Cycle Superhighways Route 8 Upgrade

Chelsea Bridge Road / Grosvenor Road

Stage 3 Road Safety Audit

Ref: 2650.F1/012/A3212/TLRN/2016

Problem Locations

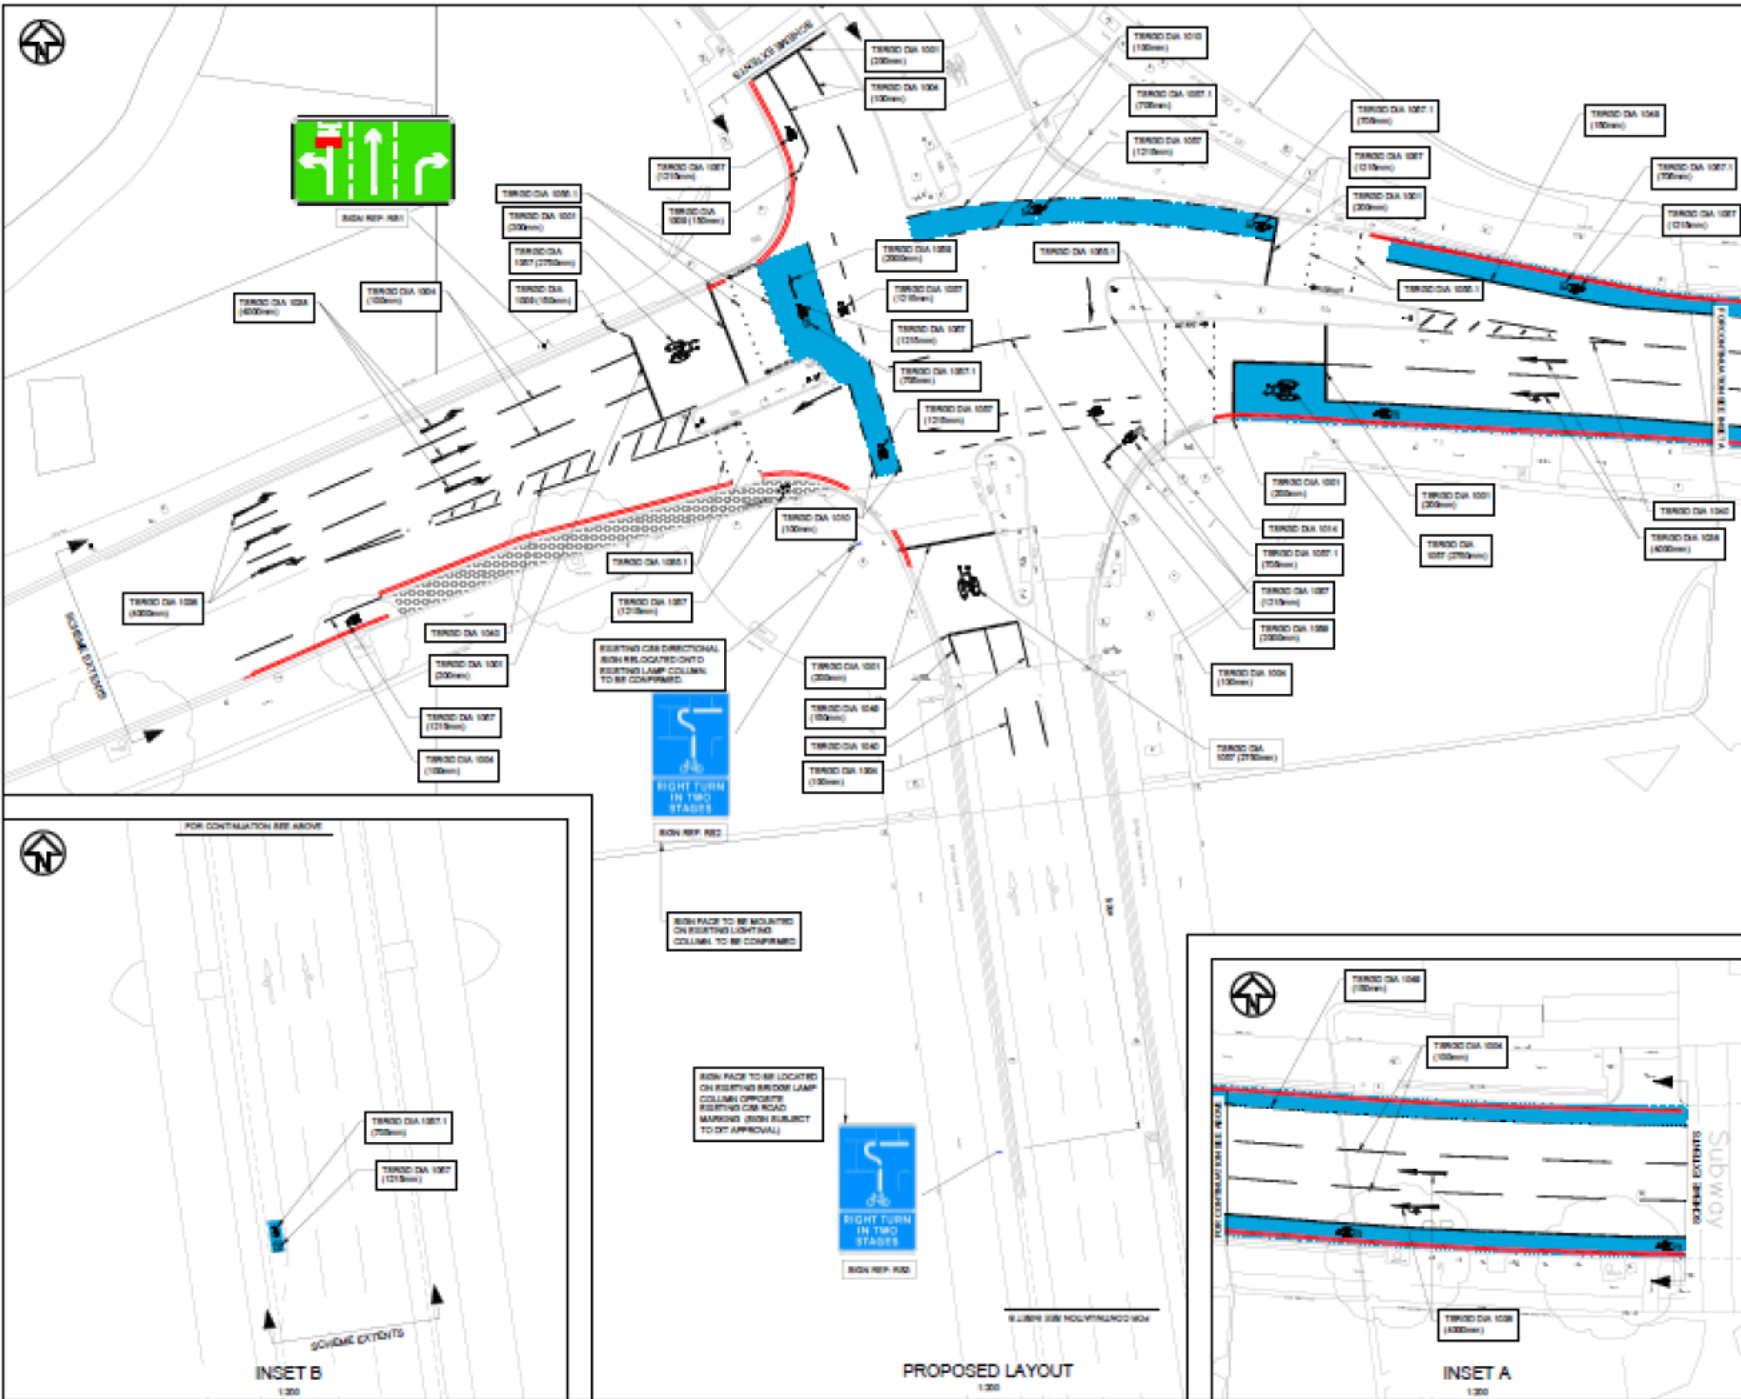
Location: A – Chelsea Bridge Road northbound right turn into Grosvenor Road

Summary: Traffic signal locations may not be immediately visible to cyclists

The implemented scheme invites cyclists to adopt a carriageway position away from the normal primary stop-line to utilise the two stage right turn facility. Encouraging cyclists to adopt this position results in them being located in front of the primary traffic signals and therefore relying on the secondary signal to decide when to progress.

The location of the secondary traffic signal may lead to cyclists failing to appreciate when it is safe to cross, with an exacerbated potential for conflict as a result. This is particularly the case if the secondary traffic signal is obscured or not operational.

It is recommended to ensure the traffic signals are located in a position where they can be intuitively seen by cyclists. This may include but is not limited to providing additional cycle specific traffic signals in sight of cyclists utilising the two stage right turn pocket.

Location: B – Chelsea Embankment junction with Chelsea Bridge Road / Grosvenor Road

Summary: Vehicles over-running the pedestrian crossing during a green pedestrian phase may result in collisions between pedestrians and motorists.

During the site visit, westbound congestion appeared to result in vehicles continuing along Chelsea Embankment during the green phase for the southern part of the pedestrian crossing on the west arm. Due to the congestion motorists were moving slowly and it is assumed this problem would not arise during free flow conditions. However, whilst vehicles continue over the crossing out of phase, an increased potential for collisions with pedestrians crossing at this location may exist, particularly visually impaired pedestrians who may not see / anticipate such vehicles.

It is recommended to alter the traffic signals to ensure that motorists do not continue across the pedestrian crossing carpet whilst pedestrians are given a green traffic signal to cross. This may include but is not limited to providing an additional traffic signal 'catch' stop-line, and / or altering the traffic signal timing to ensure that motorists clear the crossing before pedestrians are given a green signal.

Location: C - Grosvenor Road east of Chelsea Bridge Road

Summary: Vehicles over-running the mandatory cycle lane may result in an increased potential for cyclists to be clipped or squeezed

A number of larger vehicles were observed to over-run the eastbound mandatory cycle lane at the 'kink', slightly east of the adjacent hatching. This may result in an increased potential for cyclists to be clipped or squeezed as they travel along the mandatory cycle lane.

It is recommended to ensure that vehicles are provided with enough space to not encroach into the mandatory cycle lane. This may require but is not limited to altering the centre-line to afford more space to eastbound vehicles.

Location: D – Chelsea Embankment / Grosvenor Road / Chelsea Bridge Road

Summary: Vehicles in the left turn only lane may not anticipate cyclists continuing ahead from this lane which may lead to left hook type collisions

The scheme altered the lane designations so that the nearside eastbound lane changes from ahead and left to left turn only except cyclists. The Audit Team are concerned that if a motorist does not anticipate a cyclist continuing ahead from this lane they may turn left across the path of a cyclist continuing ahead, which may result in left hook type collisions.

It is recommended to provide additional features to highlight that cyclists may travel ahead from the left turn only lane. This may include but is not limited to providing 'except cycles' road marking text below the left turn arrow road markings and could also include a smaller cycle logo with an ahead arrow road marking in the Advanced Stop Line (ASL) but within the width of the nearside lane.

Location: E - Chelsea Bridge Road left turn into Chelsea Embankment

Summary: Swept path of larger vehicles may result in collisions with pedestrians

During the site visit various large vehicles were observed to utilise the whole carriageway to make the left turn from Chelsea Bridge Road onto Chelsea Embankment. This seems to have resulted in minor damage to the kerbs on the southern extent of the staggered pedestrian refuge island within the Chelsea Embankment arm of this junction. The Audit Team are concerned that the overhang of vehicles, which was observed on site, may potentially collide with a pedestrian who are unlikely to anticipate such encroachment within the pedestrian refuge island.

It is recommended to ensure that vehicles do not encroach over the pedestrian refuge island when making the turn. This may involve but is not limited to making kerb-line alterations to better facilitate the movements of larger vehicles.

Location: 1 – Chelsea Embankment eastbound approach to the junction.

The lane designation sign appears to be very close to the junction. In order to aid users to select the correct lane, as they enter the three marked lanes on this approach, it may be beneficial to relocate the sign further west. It is noted that consideration may be required of the impact of the existing advanced direction sign.

Location: 2 – Chelsea Bridge Road right turn on to Grosvenor Road.

During the site visits it was noted that only the minority of cyclists utilise the two stage right turn facility. The small minority of cyclists who did utilise the two stage right turn facility appeared to be users who were possibly less confident / slower cyclists. It is not considered a road safety concern that cyclists are not utilising the two stage right turn but it may be beneficial to try to determine how much the facility is used and why cyclists are / aren't using it. This may help determine whether further alterations / measures are likely to be beneficial to increase use of the facility.

Location: 3 - Chelsea Bridge Road junction with Chelsea Embankment / Grosvenor Road

It was noted that the second two-stage right turn sign for south to east bound cyclists is set back within the footway and may not be conspicuous to cyclists.

It may be beneficial to relocate the sign to the lighting column which is closer to the carriageway. If the lighting column is suitable this may also mean that street furniture can be reduced by removing the sign post which the sign is currently mounted on.

Location: 4 - Chelsea Bridge Road junction with Chelsea Embankment / Grosvenor Road

It was noted that on this arm of the junction, an illuminated bollard is missing from the northern extent of the pedestrian refuge island.

It is understood that this has not been altered as part of the scheme, but it is recommended that this should be replaced.

Arcadis have not undertaken the traffic signal design on this scheme and we suggest that this is for TfL signals (Traffic Infrastructure) to comment on.

The proposed location of secondary traffic signal is on the central island on Grosvenor Road, and will be clearly visible to cyclists waiting in the area indicated for two stage right turners.

The scheme does not propose low level cycle specific traffic signals owing to the eastbound traffic lanes being separately signalled on a shared stop line. The eastbound ahead/left movement has its own signal stage before the right turn movement is then permitted in the following stage. Traffic Infrastructure (TI) have analysed the specifics of the site and decided having additional cycle specific traffic signals at this site could lead to confusion for cyclists waiting to turn right and have therefore recommended:

- an increase in safety clearance time by 3s to give cyclists making the second part of the manoeuvre an additional 'safety buffer'
- signage to be installed for cyclist on the approach to the 2SRT facility
- 7.5m ASL to be provided on Grosvenor Road west

Traffic Infrastructure (TI) explained *'the secondary signal head arrangement for Chelsea Embankment ahead/left movements will be sited so that it is visible to cyclists in the two stage right turn pocket. There is no early release facility for Chelsea Embankment and so there will be no cycle specific cycle filter aspect for*

cyclists, who will use the vehicle signal head for indication on when it will be safe for them to proceed with the second stage of their turn. A longer intergreen between Chelsea Bridge traffic losing right of way and Chelsea Embankment ahead/left gaining right of way is proposed to ensure that cyclists in the two stage turn pocket will be able to proceed without obstruction and to reduce the risk of conflict between them and traffic approaching from behind.'

Design Organisation Response	Accepted / Part Accepted / Rejected
Arcadis have not undertaken the traffic signal design on this scheme and we suggest that this is for TfL signals (Traffic Infrastructure) to comment on.	
Client Organisation Comments	
The traffic signal timings have been reviewed as recommended.

Design Organisation Response	Accepted / Part Accepted / Rejected
At the point of the 'kink' there is a minimum traffic lane width of 3.0m in the eastbound direction. The two lanes in the westbound direction are also 3.0m. It is not possible to widen the cycle lane at this point without taking space from the traffic lanes or widening the carriageway. Neither of these options were possible as part of this scheme as the traffic lane widths were at a minimum and there was no scope to widen the carriageway due to the structure underneath the road at this location.	
It is recommended that proposed reflective plastic bollards (wands) are installed, starting at the start of the mandatory cycle lane and finishing after the 'kink'. This should provide protection for cyclists in the mandatory cycle lane and force vehicles into a better road position after the island.	
Client Organisation Comments	
Agree with designer's comments that the option to widened the carriageway or alter the centre-line to afford more space to eastbound vehicles is not feasible due to the carriageway constraints at this location.

The recommendation to provide light segregation in the form of 'wands' would not be appropriate as the provision of wands reduces the effective width of the cycle lane to 1.2m at the kink and is likely to create a hazard for the high flow of cyclists using CS8. This was discussed and agreed with the Road Safety Auditor and therefore this issue will continue to be monitored going forward.

The current eastbound approach to the junction indicates that cyclists should be in the primary position (central to the lane) on the approach to the junction. There are currently no road markings to guide cyclists into a secondary position (nearside of lane) on this approach. However, it is accepted that less confident cyclists are unlikely to take a primary position on this road due to the traffic volumes and types of vehicles that use the route. This may lead to a conflict between a motorist and cyclist if the motorist does not expect the cyclists to be in the secondary position whilst turning left at the junction. This conflict is very difficult to mitigate in this road layout. It is the designer's opinion that there are no solutions within the very restricted road space currently available, unless TfL implement;

- A reduction in the number of lanes (from 3 lanes to 2 lanes to introduce space for a formal on-road cycle facility) on the approach to the junction; however, the Designer suspects this would lead to capacity issues.
- Changes to the lane designations (changing the lane designation of the nearside lane to left and ahead as oppose to left only), but this would have a knock-on effect on the kerb alignments within the body of the junction.
- A widening to the carriageway; but the Designer acknowledges that may would be difficult due to the limited space.

Any of these solutions would further compromise the road network.

Other solutions have been reviewed but none have been found to further improve the current situation, these include;

- It is believed that the Auditors suggested 'except cycles' road markings do not feature in the 'Traffic Signs Regulations and General Directions 2016' document and we observe that it is unlikely that the text would fit in the available lane width. We feel that there would be too much text in a limited space and it would become illegible. It would also introduce signing clutter and increase driver distraction.
- An advisory cycle lane to guide cyclists into the middle lane – it is believed that this would add further conflict due to increased weaving manoeuvres to establish lane positions.
- A warning sign to motorists of potential conflict with cyclists – it is believed that an additional sign on this approach would serve to distract motorists further rather than warn them.

A potential improvement may be to install green cycle signal aspects below the existing left turn and ahead only signal heads.

Client Organisation Comments

Agree with the designer's response that options have been considered however are not viable, including 'except cycles' road marking text below the left turn arrow road markings.

To ensure motorists are aware of cyclists signage has been provided on the approach to the junction clearly indicating that cyclists can travel ahead in the nearside lane.

It is accepted that the evidence of tyre marks on the kerbing may be a result of the left turn manoeuvres at this location.

During the design phase, this left turn movement was extensively tracked and the manoeuvre was found to pass the vehicle tracking exercise. However, the vehicle tracking software does not account for driver behaviour. There is potential to reduce the width of the western end of the island back to the original dimensions, however this would reduce the waiting space available to pedestrians and it would not be within TfL's preferred refuge width guidance in the Streetscape Guidance document (2.5m for staggered islands).

There is also an equal possibility that the marks on the kerbing are resulting from westbound traffic merging from two to one lane on the exit from the junction.

An additional merge arrow and sign have been installed prior to the exit of the junction to guide motorists to merge as early as possible and also prevent them from getting caught two abreast where the roads narrows.

Tracking of the left turn shows there are no issues when undertaken at the appropriate speed. Site observations by the client indicate that this is likely to be driver behaviour issue. Reducing the width of the crossing to the original dimension would result in sub-standard island width.

Damage sustained to the kerb is most likely to have resulted from westbound traffic failing to have merged correctly. Additional signage and road markings have been provided prior to the merger to mitigate against this.

Design Organisation Response	Accepted / Part Accepted / Rejected
We acknowledge that the lane designation sign appears to be close to the junction. However, the reason for this is that the lane designation sign had to be installed 35m away from the existing directional sign for visibility requirements (re. The Design and Use of Directional Informatory Signs, LTN 1/94). The position of the lane designation sign also had to take into account the visibility constraints presented by the existing large trees on the approach to the junction.	
The final position took both factors into account and the sign was installed at the optimal location.

Agree with designer's comments

This is an operational consideration for TfL.

Two-stage right turn facilities are new to London and it is anticipated it will take time for cyclists to become more familiar with them. They in particular provide a benefit for less confident cyclists, who are observed to be using the facility. TfL will continue to monitor two-stage right turn facilities.

The construction drawings issued by Arcadis proposed that the second two-stage right turn sign (Sign Ref: RS2) should be mounted on the lamp column to the west of the northbound ASL. It is therefore recommended that the sign is installed as per the design drawings.

In addition to the two-stage right turn sign at the junction there is also a two stage right turn sign on the approach on Chelsea Bridge. This sign should reinforce the understanding of the layout of the junction to cyclists.

Agree with designer's comments, the contractor has been instructed to install the signs in the correct location

This is an operational consideration for TfL.

This is a maintenance issue and has been passed on to the Asset Management Team
